PLANNING COMMISSION AGENDA

**Planning Commission Meeting
6:30 PM Thursday, February 11, 2016**

RE: Case 15-01P, Revision to Site Plan Review for Country Attic Treasures LLC

RE: Case 16-01P, Preliminary Plat - Rivers Crossing South

EXAMPLE OF BASIC GATE LAYOUT—NOT TO SCALE

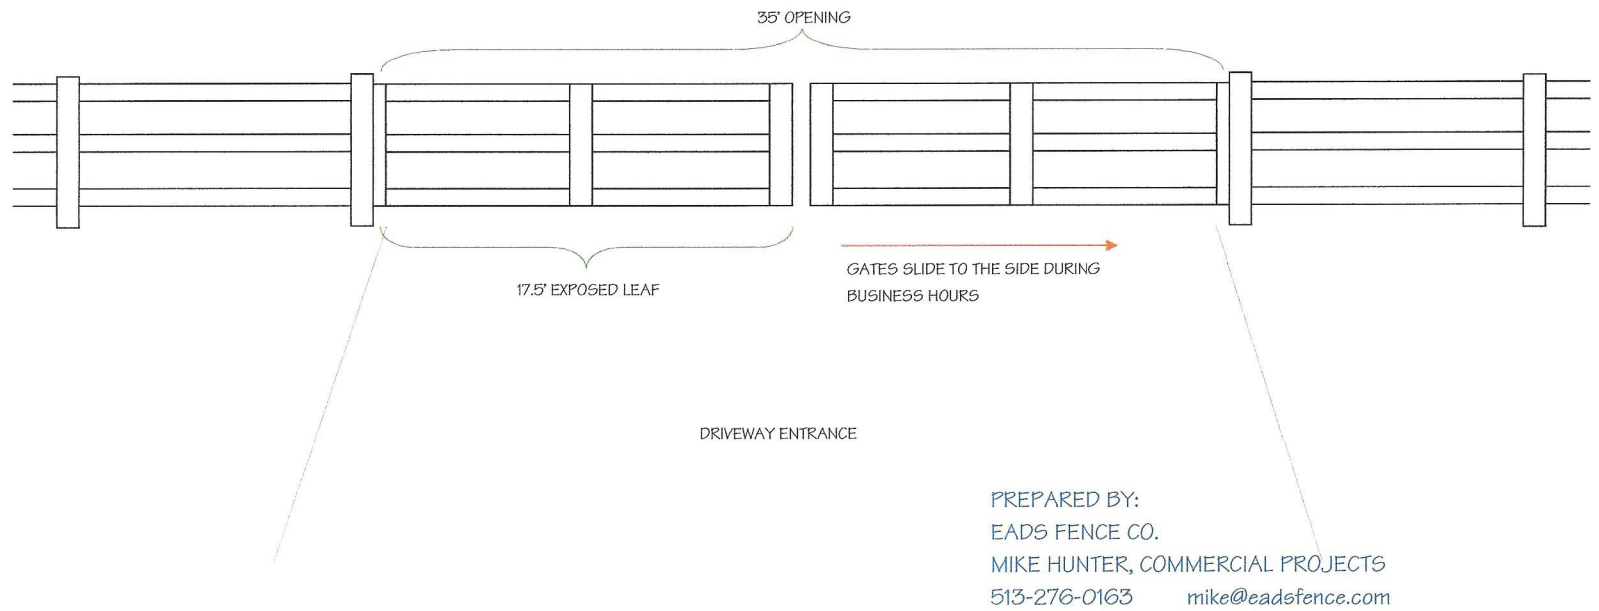
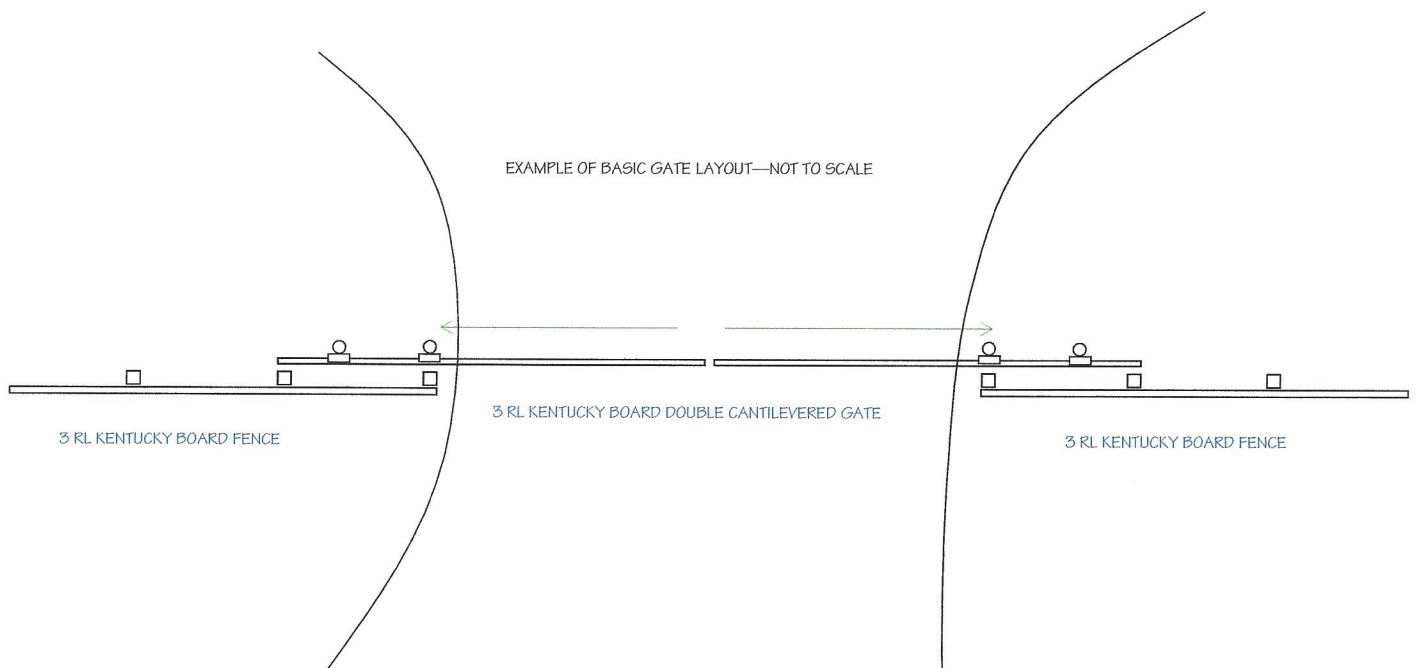
With respect to the proposed gate, the Applicant, citing security concern, is seeking permission to install a sliding gate to limit access to the property during non-operating hours. Although the Zoning Code does not specifically address this item, Sec. 15.18.21.8 Standards for Site Plan Approval that “all buildings or groups shall be so arranged as to permit convenient and direct emergency vehicle access.” The installation of a gate, whether locked or unlocked, would impede access to the property by emergency vehicles and personnel.

- A. Staff recommends that the Planning Commission grant its approval to fencing portion of the request with the following conditions:
 - 1. Review and approval of fence materials by the Zoning Administrator prior to installation;
 - 2. Breaks in the fence every fifty (50) feet, per the Village Commercial Standards and Guidelines;
 - 3. Setback from property line to allow for landscaping; and
 - 4. Apply for Zoning Permit to install fence.
- B. Staff recommends denial of the gate portion of this request.

Fence & Gate
Location
Shown in Red.

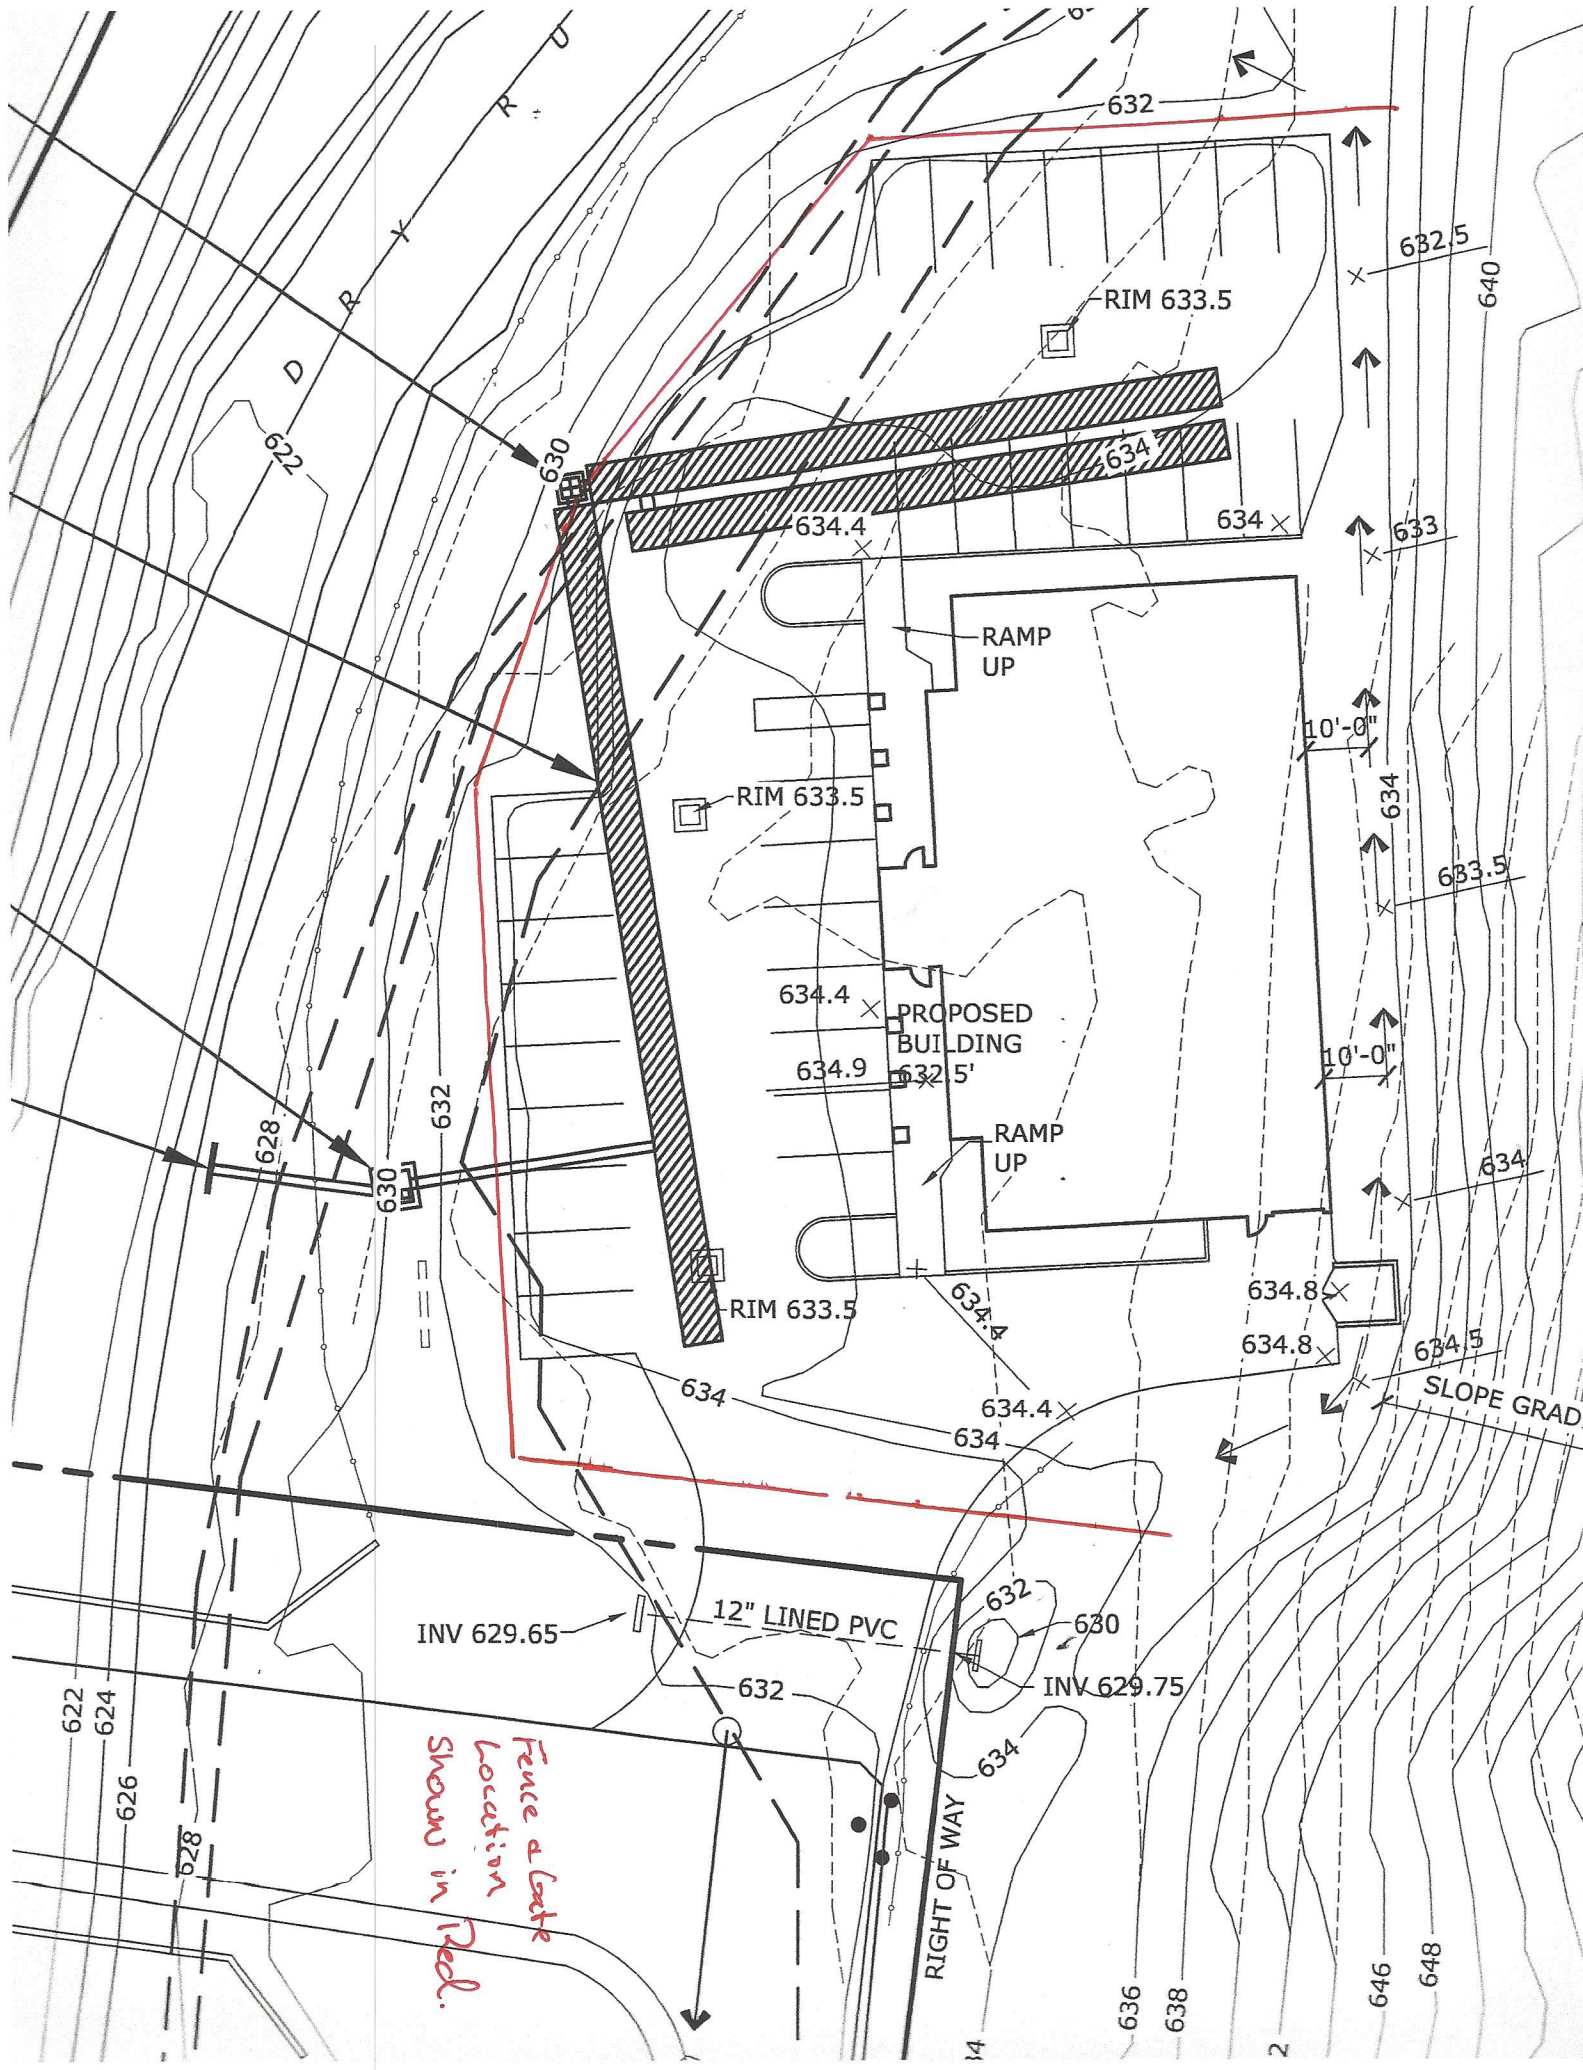
Based on the information provided, the fencing portion of the request would adhere to the Village Design Guidelines as well as providing a barrier between the parking lot and Dry Run located on the west side of the property. The 3 board fence would also enhance look of the building from the street

PRELIMINARY PLAT

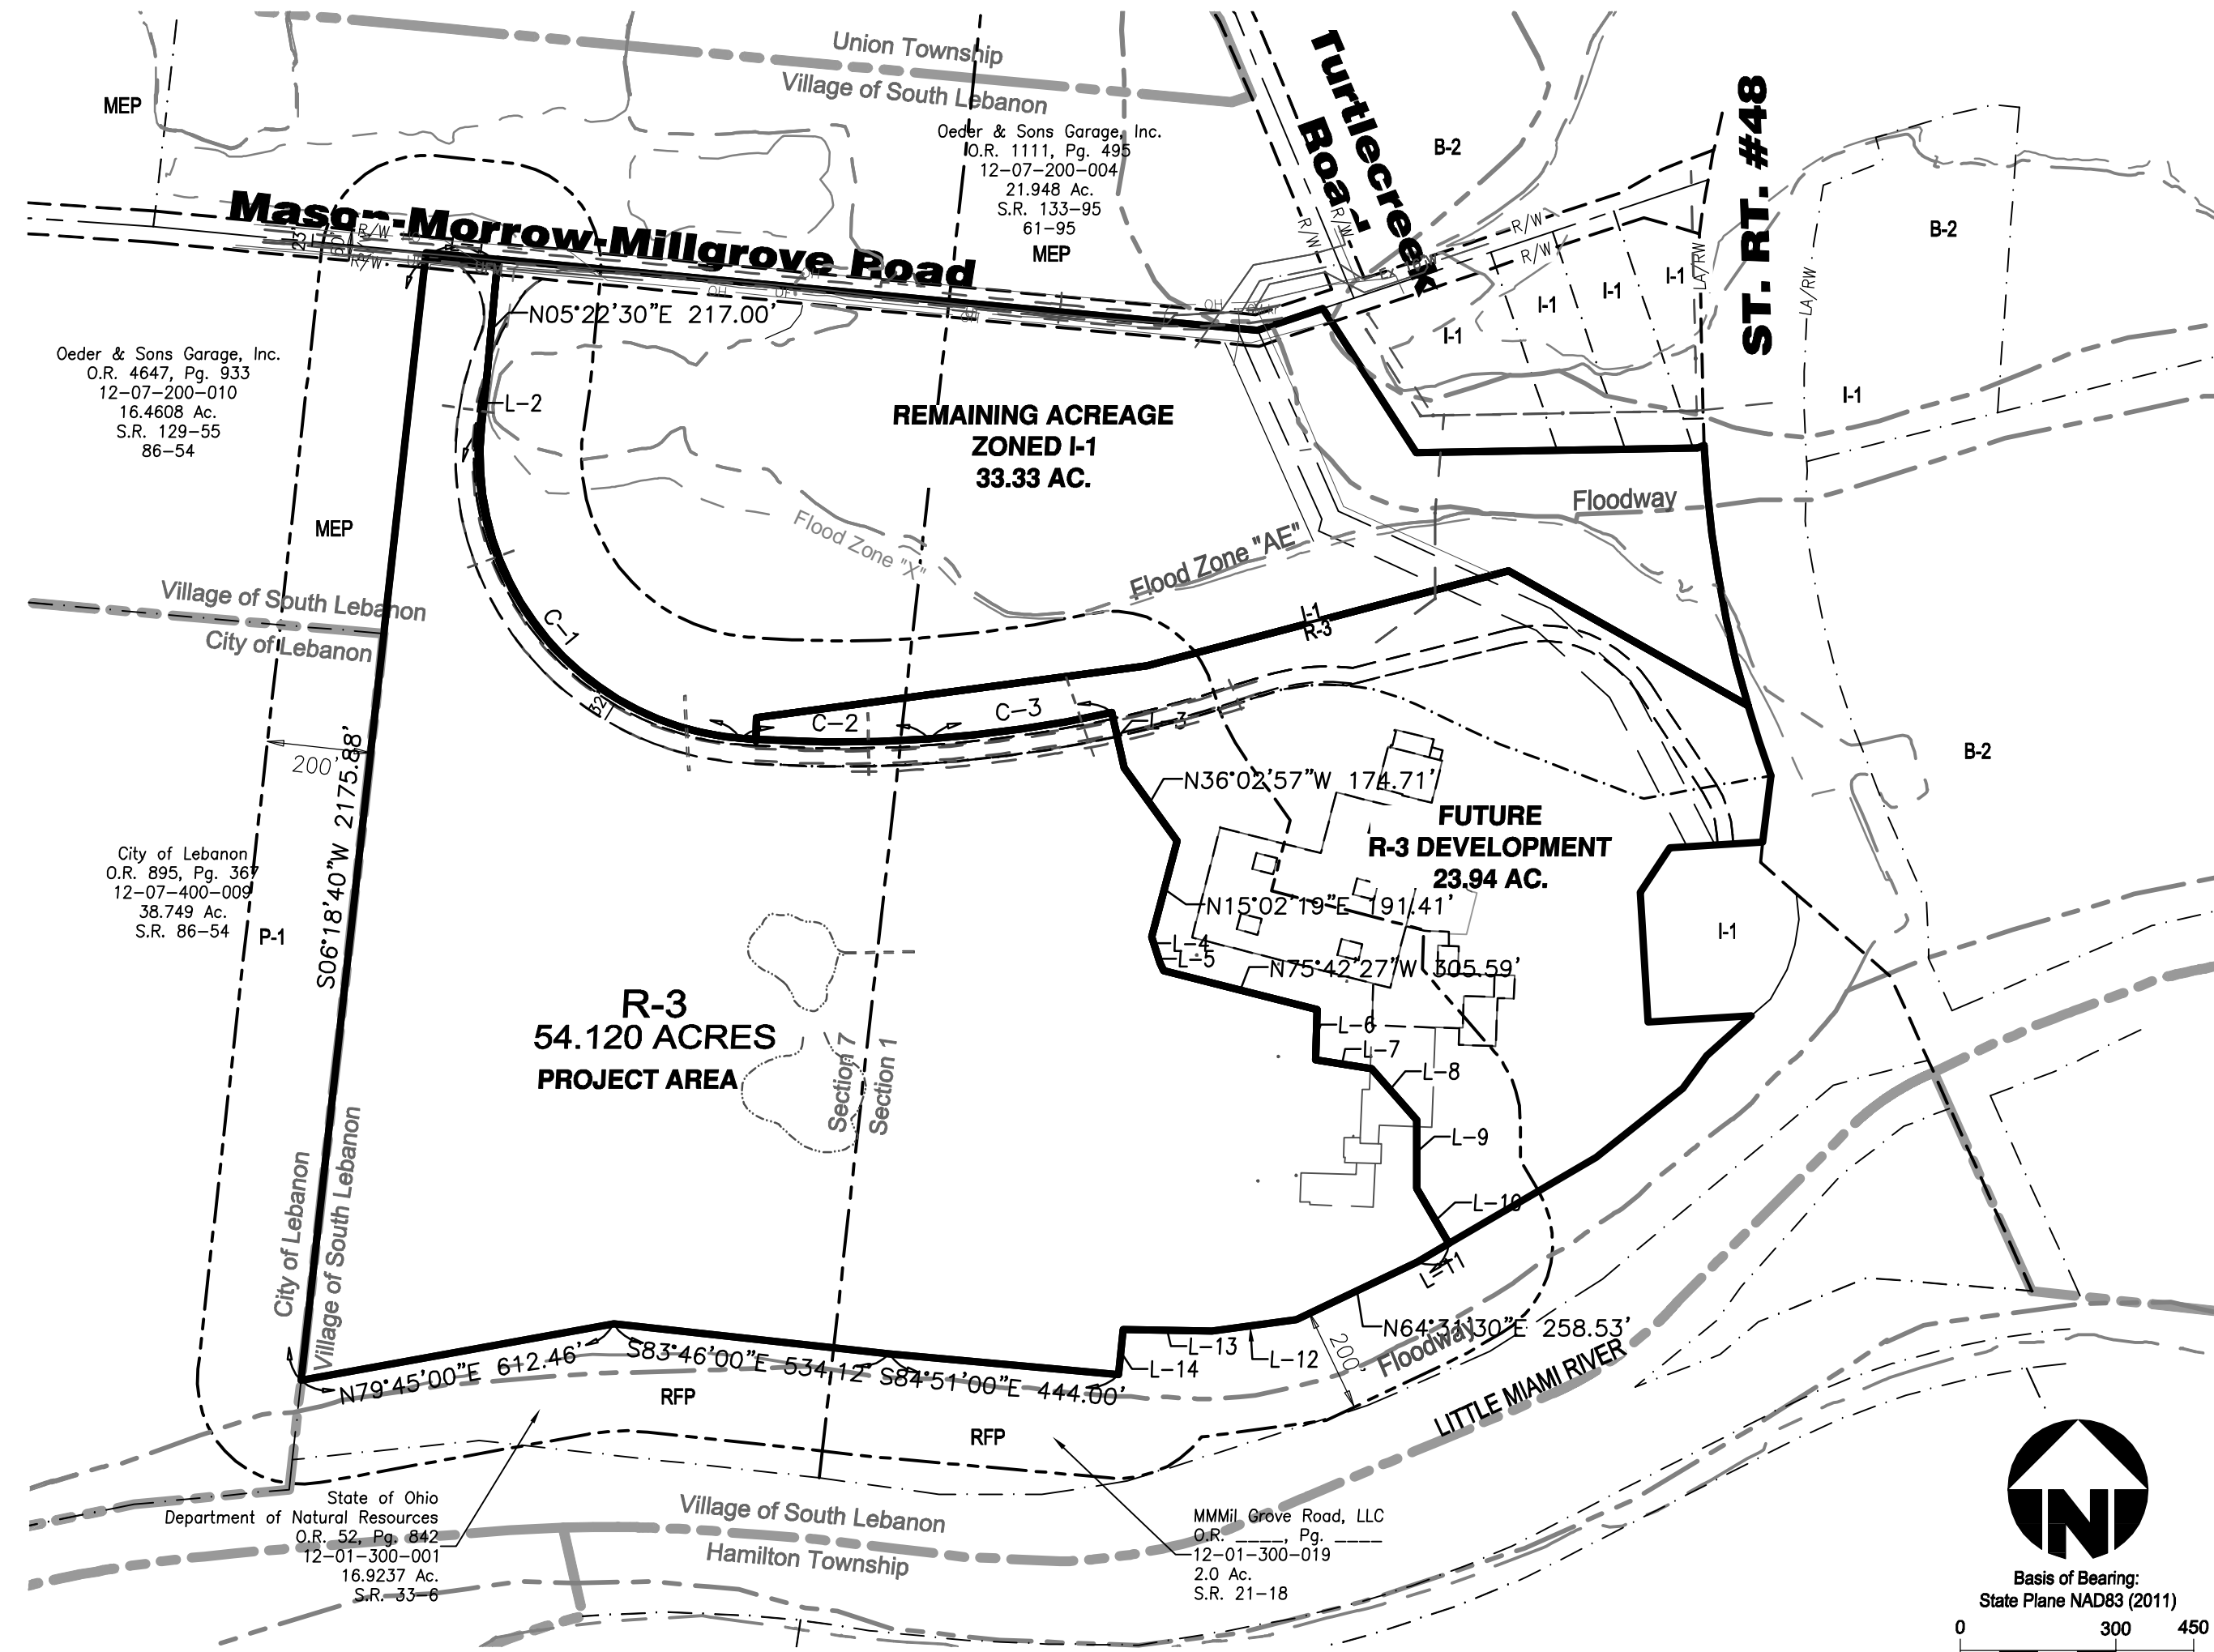
1. The water supply for the fire suppression system, sprinklers, for the "Existing Manufacturing Facility", is supplied from the two existing ponds on site. The pumps for the sprinkler system are in a vault, 30' underground, near the proposed lots #124 & #107. There are two pumps in the "Pump Vault". The main fire pump is electric with a diesel back-up. Also the secondary water supply is atop the "Tower" in a 30,000 gallon tank. With the "Tower" to be demolished and the "Pump Vault" having housing built on its location, how is the water supply going to be maintained to the "Manufacturing Facility"? This facility appears to be currently occupied.

2. With the high density of housing proposed, the on street parking to be restricted from the hydrant side of the street and not at all in the cul-de-sacs.

3. All turns, intersections and cul-de-sacs to be able to handle a large ladder type truck to be able to turn.
4. Hydrant placement, is it possible to move the hydrants behind the sidewalks instead of between the curb and sidewalk? This will keep snow from being piled up on them.

Jerry,
I only have a couple comments since this is only the preliminary plan.
Plans must make special considerations to protect the Little Miami River during construction. Such considerations might be double silt row fencing along the river, buffer space and sediment pools at outlet headwalls. I would also like to see the recommended streamside setbacks shown on the sediment and erosion control plan. This information can be found digitally by contacting the Warren Co Regional Planning.
Thank you,

1. Address the comments/concerns of the Union Township Fire Department with the exception of item #4 re: re: hydrant placement. This item is addressed in the Village Water Design Standards;
2. Ensure adequate sediment and erosion control measures are used during construction per the Warren County Soil & Water Conservation District email attached;
3. Submit a plan/timetable for demolition of the existing buildings on the property; and
4. Ensure compliance with any applicable Federal, State or local law or regulation
